SUNDRY NOTICES AND REPORTS ON WELLS
Do not use this form for proposals to drill or to re-enter an abandoned well. Use form 3160-3 (APD) for such proposals.

Devon Energy Production Company, L.P. respectfully requests to make the following changes to the subject well:

Drilling Program
Cotton Draw Unit 225H
SRY 3.4.14

OPERATOR'S NAME:	Devon Energy Production Company, L.P.
LEASE NO.:	NMNM-0503
WELL NAME & NO.:	Cotton Draw Unit 225H
SURFACE HOLE FOOTAGE:	0200' FNL & 1115' FWL
BOTTOM HOLE FOOTAGE:	0330' FSL & 0660' FWL
LOCATION:	Section 11, T. 25 S., R 31 E., NMPM
COUNTY:	Eddy County, New Mexico
API:	30-015-42414

DRAWING NUMBER
DM100161771-2A

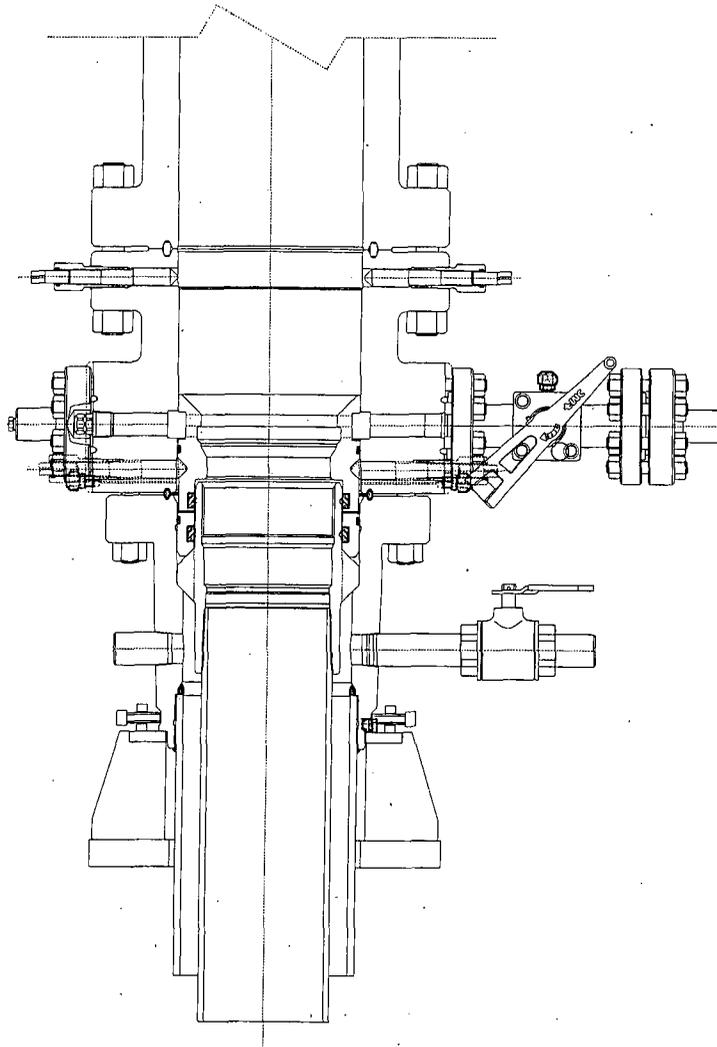
Devon proposes using a multi-bowl wellhead assembly (FMC Uni-head). This assembly will only be tested when installed on the surface casing. Minimum working pressure of the blowout preventer (BOP) and related equipment (BOPE) required for drilling below the surface casing shoe shall be 3000 (3M) psi.

- Wellhead will be installed by FMC's representatives.
- If the welding is performed by a third party, the FMC's representative will monitor the temperature to verify that it does not exceed the maximum temperature of the seal.

- FMC representative will install the test plug for the initial BOP test.
- FMC will install a solid steel body pack-off to completely isolate the lower head after cementing intermediate casing. After installation of the pack-off, the pack-off and the lower flange will be tested to 5M, as shown on the attached schematic. Everything above the pack-off will not have been altered whatsoever from the initial nipple up. Therefore the BOP components will not be retested at that time.

3. **Operator has proposed a multi-bowl wellhead assembly. This assembly will only be tested when installed on the surface casing. Minimum working pressure of the blowout preventer (BOP) and related equipment (BOPE) required for drilling below the surface casing shoe shall be 3000 (3M) psi.**

- a. **Wellhead shall be installed by manufacturer's representatives, submit documentation with subsequent sundry.**
 - b. **If the welding is performed by a third party, the manufacturer's representative shall monitor the temperature to verify that it does not exceed the maximum temperature of the seal.**

- c. **Manufacturer representative shall install the test plug for the initial BOP test.**
 - d. **Operator shall perform the intermediate casing integrity test to 70% of the casing burst. This will test the multi-bowl seals.**

- e. **If the cement does not circulate and one inch operations would have been possible with a standard wellhead, the well head shall be cut off, cementing operations performed and another wellhead installed.**
